Wisconsin Department of Transportation

Proposal #37: 6998-13-73, WISC 2025057
C Stevens Point, West Zinda Drive
Rocky Run Creek Bridge B-49-0061
Local Street
Portage County

This is Addendum No. 01, which provides for the following:

ADDENDUM NO. 01

Addendum No. 01
ID 6998-13-73
Revised Sheet 4
October 22, 2024

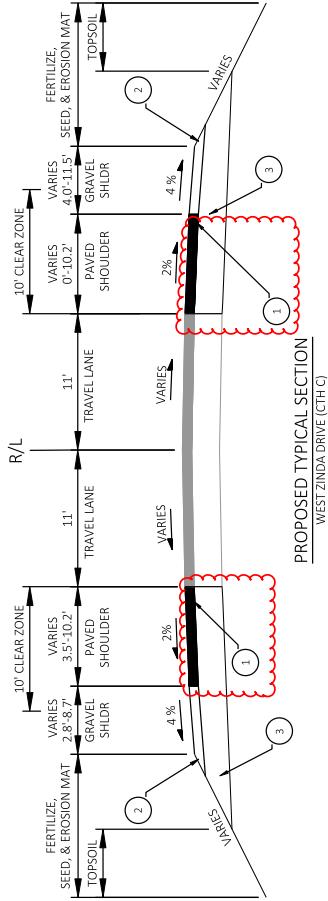
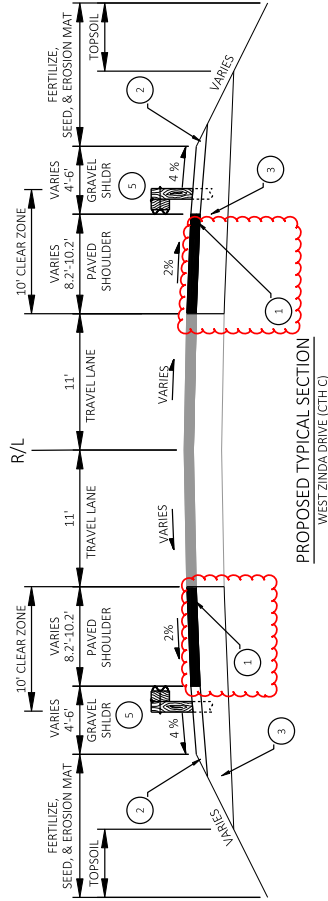
Revised Plan Sheets	
Plan Sheet	Plan Sheet Title (brief description of changes to sheet)
2	General Notes (Updated General Notes to include Asphaltic Surface)
4	Typical Sections (Updated legend to include Asphaltic Surface)
5	Typical Sections (Updated legend to include Asphaltic Surface)
15	Miscellaneous Quantities (Updated to Asphaltic Surface Bid Item)
68	Typical Section & Quantities (Updated Concrete Masonry Bid Items)

- 1 5.25" ASPHALTIC SURFACE
- 2 5.25" BASE AGGREGATE DENSE 3/4-INCH
- 3 12" BASE AGGREGATE DENSE 1 1/4-INCH
- 4 CONCRETE CURB & GUTTER
4-INCH SLOPED 36-INCH TYPE TBT
- 5 STA 8+62.05 TO STA 9+20.64 LT & RT
PROPOSED GUARDRAIL
STA 8+30.61 TO STA 9+23.14 LT & RT
STA 10+76.30 TO STA 11+68.82 LT & RT
